NFPA 70®-2020, 2023 and 2026 Editions

National Electrical Code®

TIA Log No.: 1924

Reference: 210.8(F) Exception No. 2

Figure 4-7. Spaghetti plot of all GFCI trip curves over proposed HF and HF+ requirements

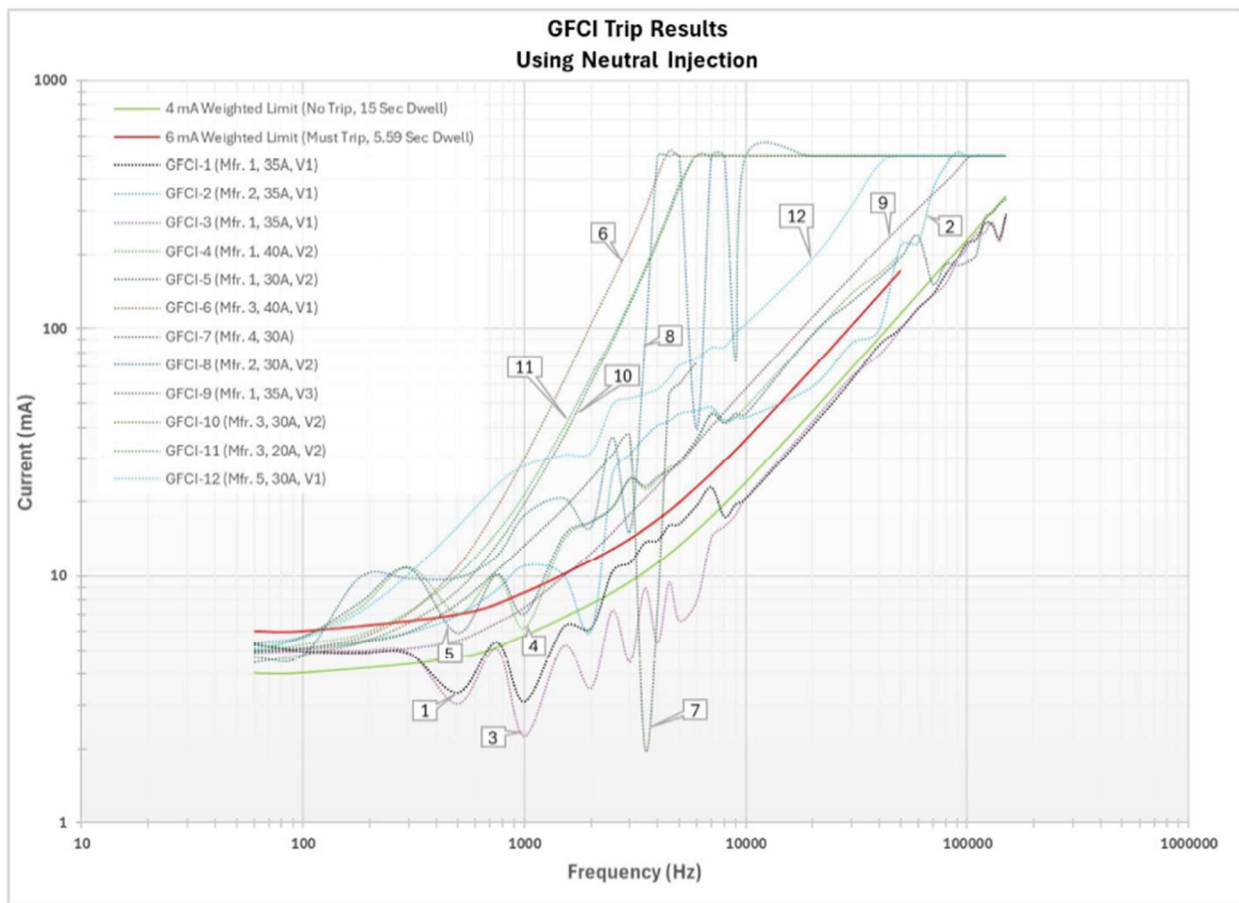
GFCI devices exhibit wide variability in response to high-frequency differential current. Some devices trip at relatively low HF current magnitudes at specific frequencies, while others remain robust to the same stimulus (see attached Figure 4-7).

Not all standards-compliant GFCIs behave the same under HF conditions. Testing showed that some devices tolerate high injected currents at certain frequencies without tripping, while others trip at significantly lower levels.
